DOCKET NO. 40-9027

LICENSE NO. SMC-1562

LICENSEE: CABOT PERFORMANCE MATERIALS, REVERE,  
PA

SUBJECT: SAFETY EVALUATION REPORT, SITE  
DECOMMISSIONING PLAN AND RADIOLOGICAL  
ASSESSMENT DATED FEBRUARY 28, 2001

**Figure 1.** Generalized conceptual model used in the Cabot-Revere assessment.

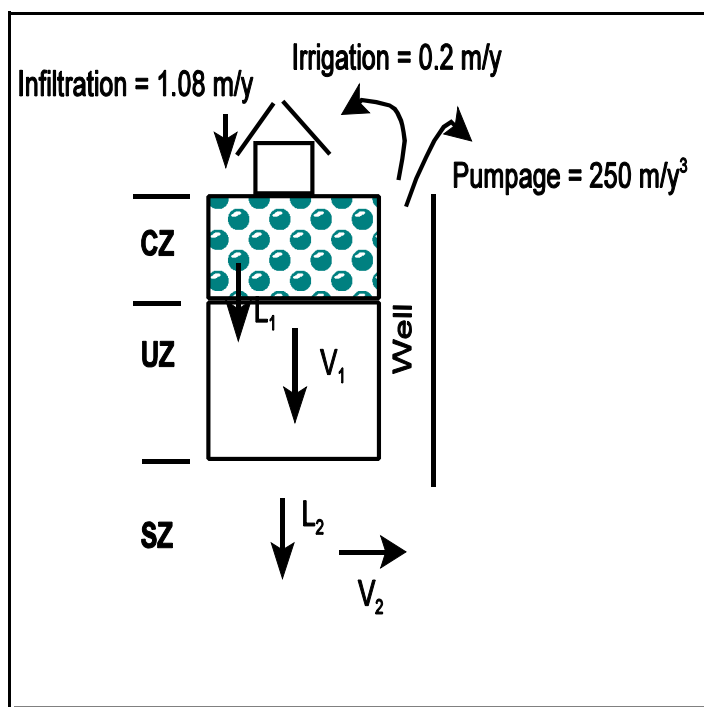
Figure 1 shows a schematic of the general conceptual model used in the Cabot-Revere radiological assessment, based upon staff's interpretation of the information presented in the report.

It should be noted that a default irrigation rate of 0.2 m/y was used in the analysis although the licensee only assumed irrigation as part of their residential gardener scenario.

Based on regional information, the unsaturated zone is believed to be roughly 20 meters thick; however, for the assessment nominal credit is taken for the possible hold-up of contaminants migrating through the unsaturated zone. This is reflected by the small unsaturated zone thickness (0.01 m) assumed for the analysis. Staff believes that this adds conservatism to the calculated doses for the water-dependent pathways.
